Reversal of Alternative TS-7

SUBJECT: Request To Reverse Implementation of VE Study Alternatives

SUBJECT: IMPLEMENTATION OF VALUE ENGINEERING STUDY ALTERNATIVES

VALUE ENGINEERING STUDY REPORT RESPONSES

Attachment:
Right of Way Plan sheet

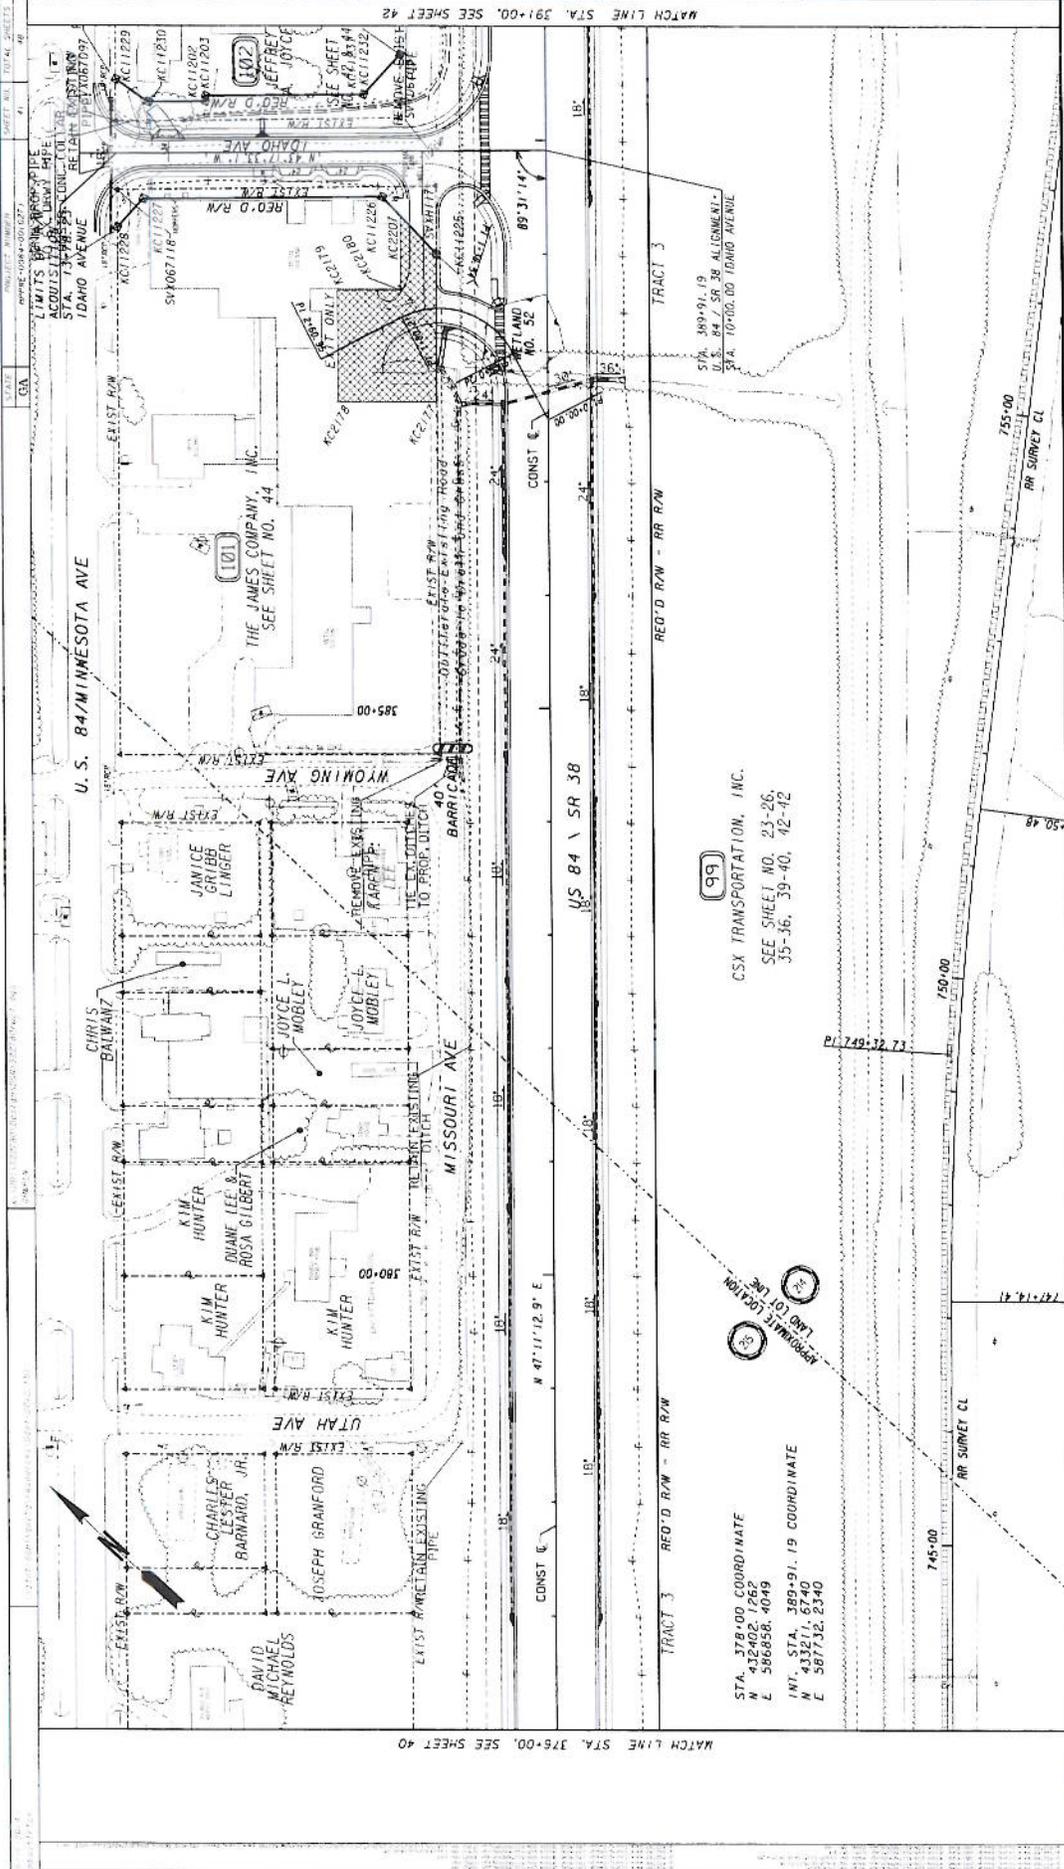
Reversal of Alternative INT-9

DESCRIPTION: **RELOCATE CONNECTOR FROM IDAHO AVENUE TO WYOMING AVENUE IN PROJECT EDS-84(27)** SHEET NO.: **1 of 2**

The original design provides improvement to Idaho Avenue (STA 290+00) to act as a connector between the existing road and the new road.

Relocate the connector to Wyoming Avenue (STA 284+20, labeled “Oregon Avenue” in the plans).

Idaho Avenue extends from the new alignment for only two blocks before ending at Illinois Avenue. Wyoming Avenue extends eight blocks to Wadley Road, providing superior connectivity. Also, Wyoming Avenue appears to be a bigger street, so it is possible less construction will be required.

- INT-9 Relocate connector (roadway extension) from Idaho Ave to Wyoming Ave2
The connector will be relocated from Idaho Avenue to Wyoming Avenue.
